ADDENDUM #1

To BID #27017

TUSD School Fencing Project

December 22, 2025

B. Hardware sets for swing gates shall include:

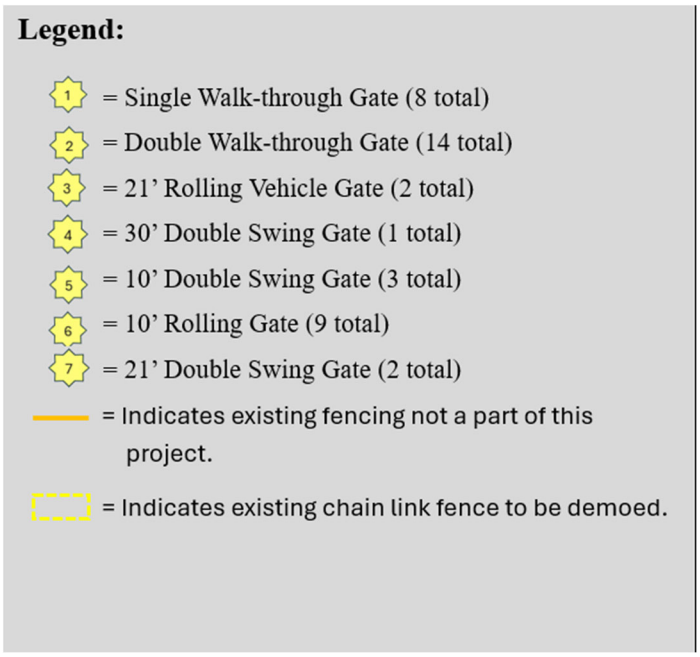
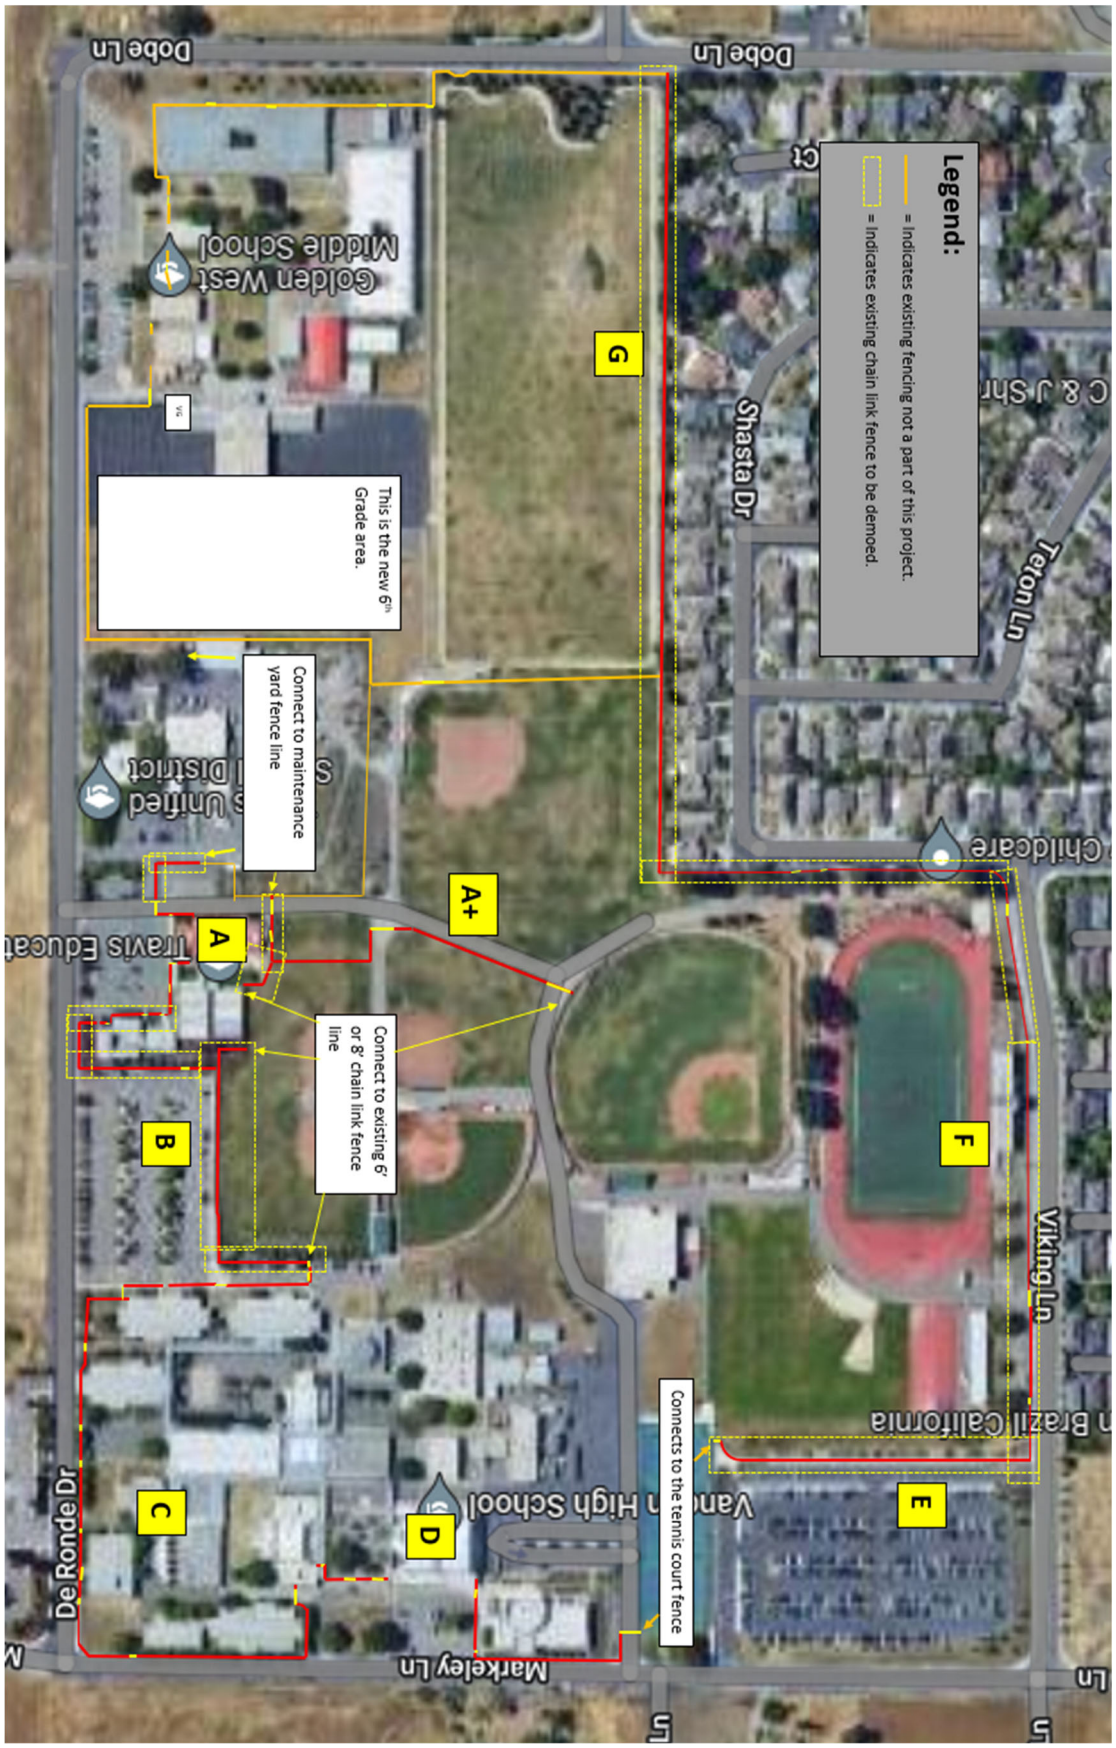
i. Heavy Duty Barrell Hinge King Kong 44-2000
ii. Heavy Duty Square Frame Fulcrum Strong Arm Gate Latch w/ Lockable Tabs
iii. Wall Stop & Holder 1283-4S (As Req'd) 626 TR
iv. 1" Thick Cane Bolts

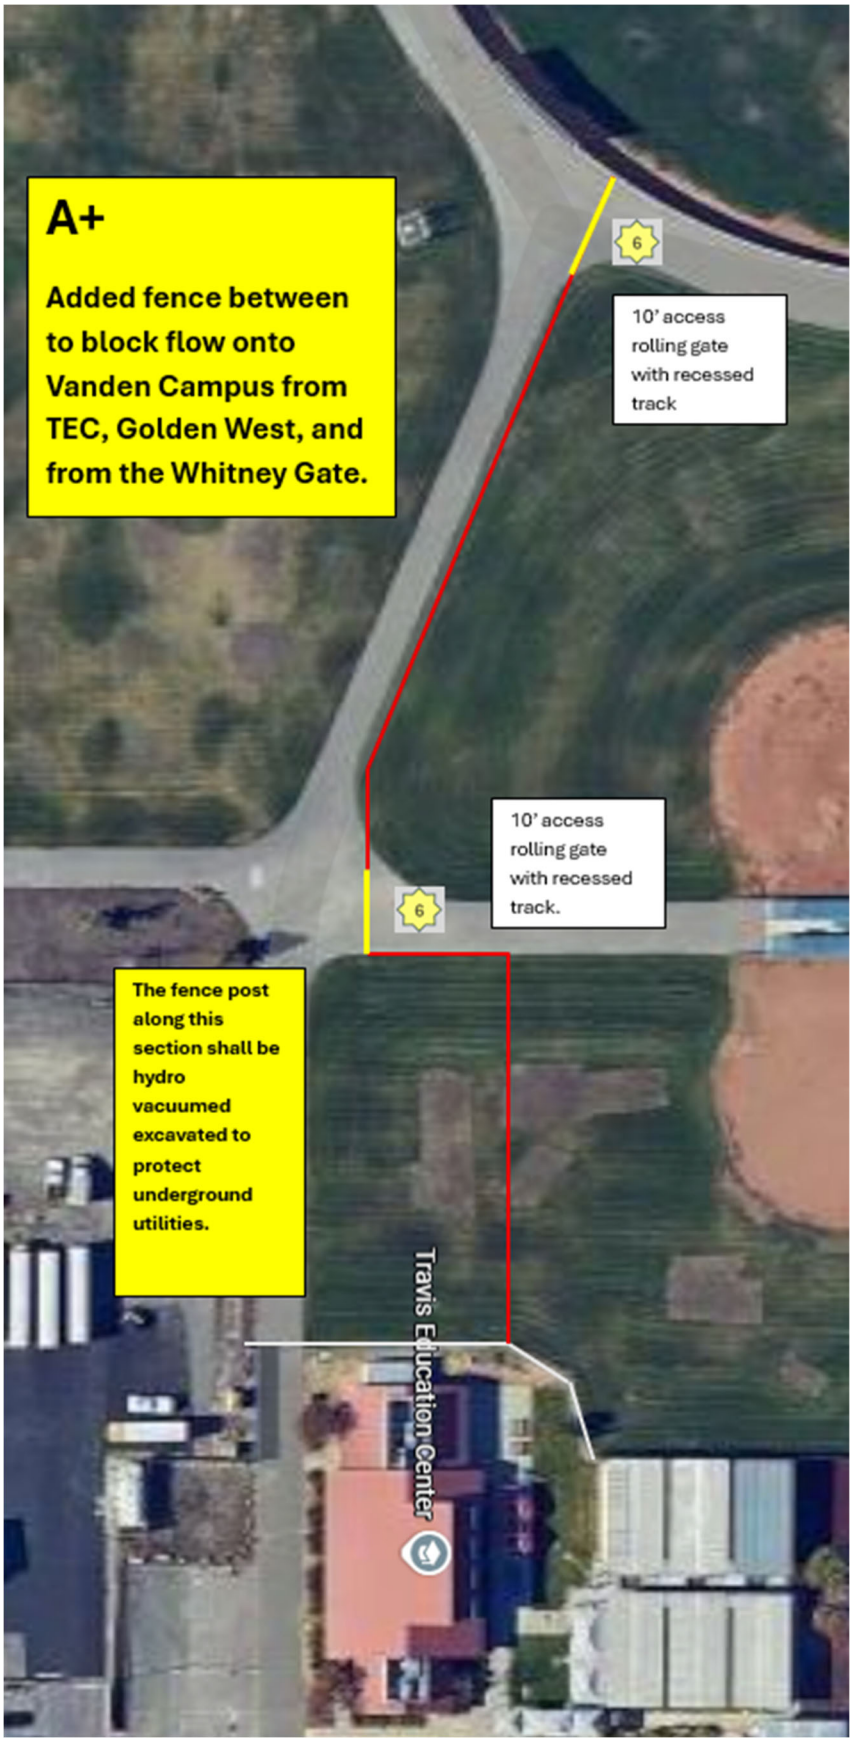
J. The District has 62 two rail panels of the Fortress brand Industrial Ornamental Fencing to be used on this project. The panels are 7' tall and 90.5" wide. Bid shall account for these panels to be used on TEC campus as indicated on the changed diagram "A" in this addendum. Gates shall match the height of these panels

10' access swing gate (5' panels)
TEC Campus
Connect to existing 8' chain link.
Add concrete walkway (@ 15'x7') to exit gate.
A
Travis
10' Access swing gate and walk thru gate
Connect to bus yard chain link fence.
21' rolling vehicle gate with recessed track. Per the City of Fairfield Fire Code, STD# 02-24, gate "shall provide a minimum of 20' clear opening when gate is in the open position."
De Ronde Dr
De Ronde Dr
De Ronde Dr

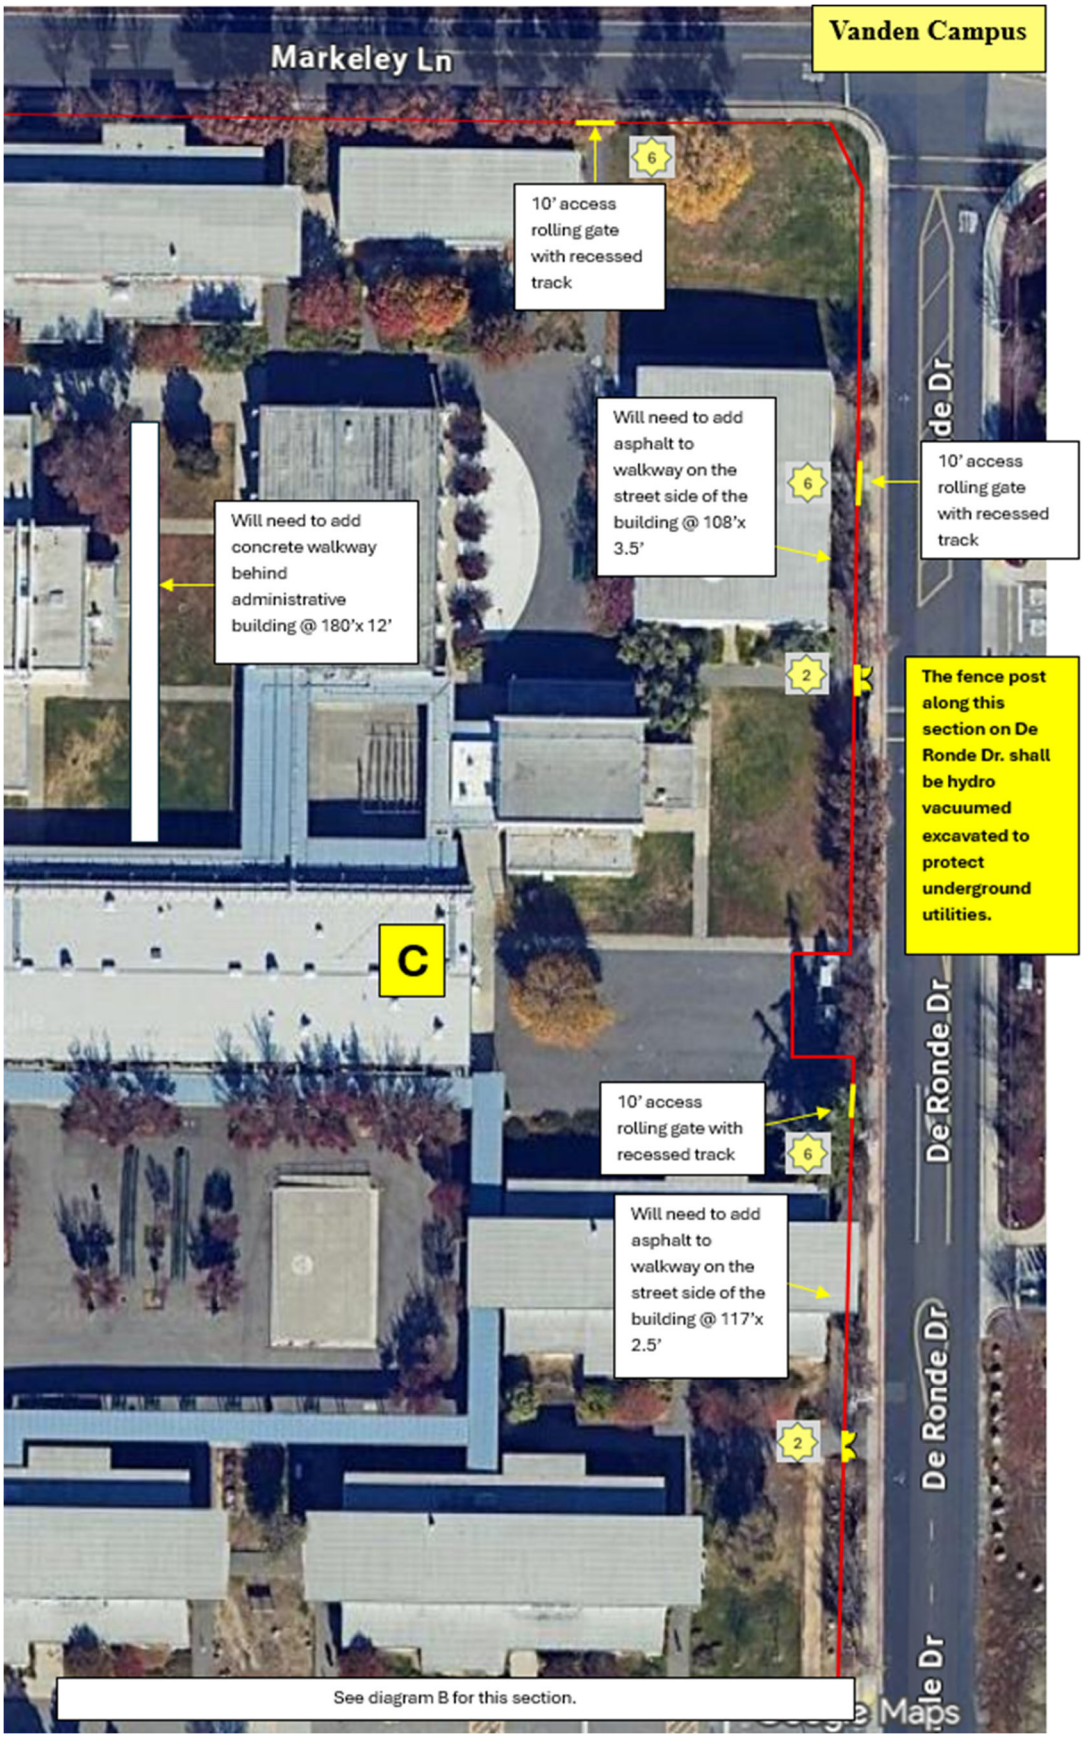
A+
Added fence between to block flow onto Vanden Campus from TEC, Golden West, and from the Whitney Gate.
6
10' access rolling gate with recessed track
10' access rolling gate with recessed track.
6
The fence post along this section shall be hydro vacuumed excavated to protect underground utilities.
Travis Education Center
